First Amendment to the Draft SEIR

Almaden Office Project

File No. SP20-005

August 2021

Figure 2.4-4 Existing Conditions Plan With Easements

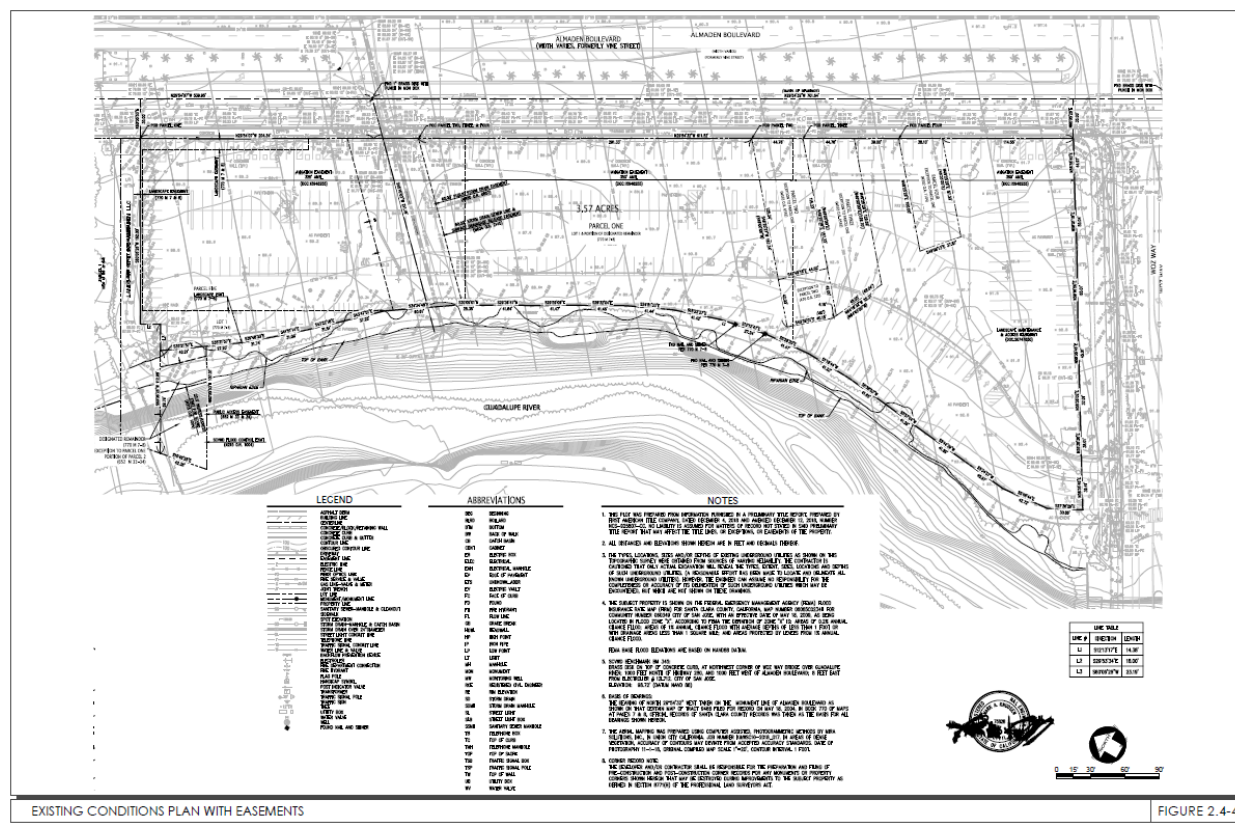
A new graphic will be **ADDED** as follows:

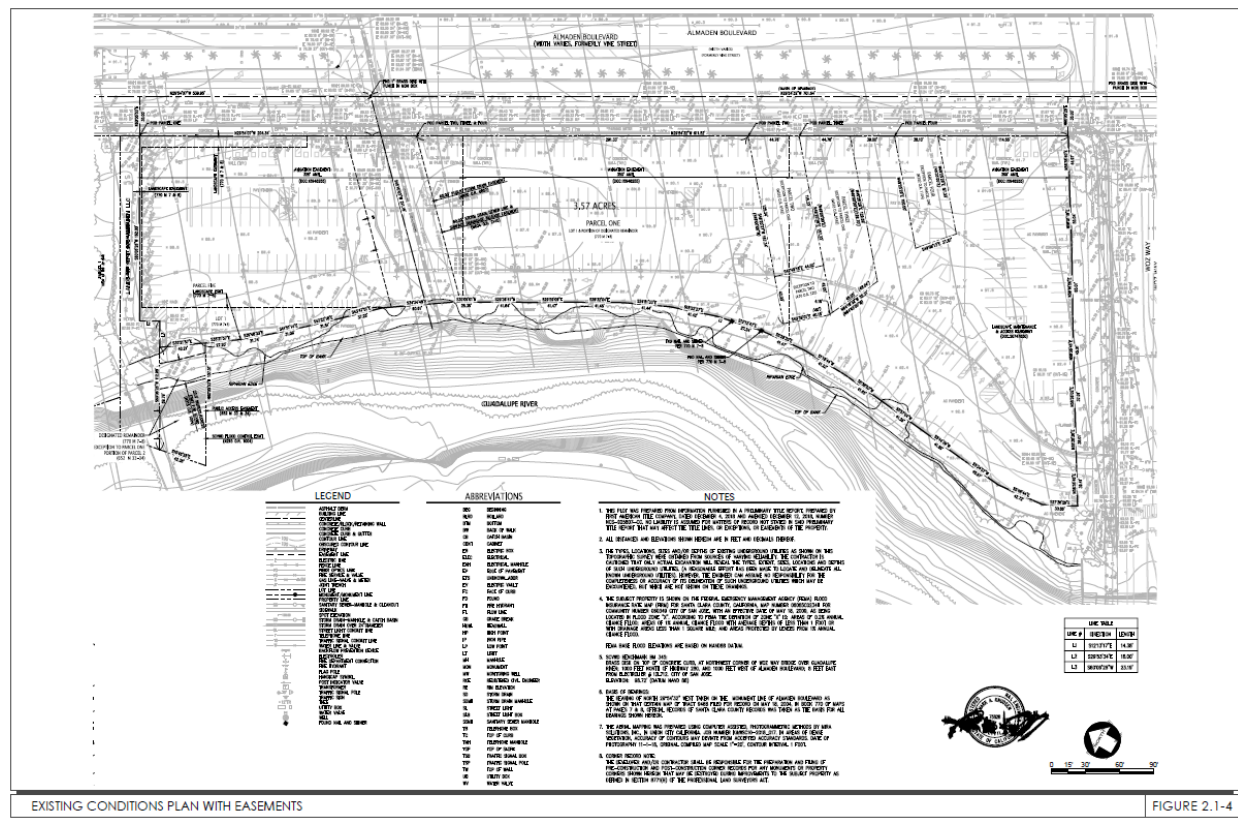
The last sentence under Subsection 2.1 will be **REVISED** as follows:

Refer to Figures 2.1-1 to 2.1-34 for the regional, vicinity, and aerial maps and the existing conditions plan with easements figure maps.
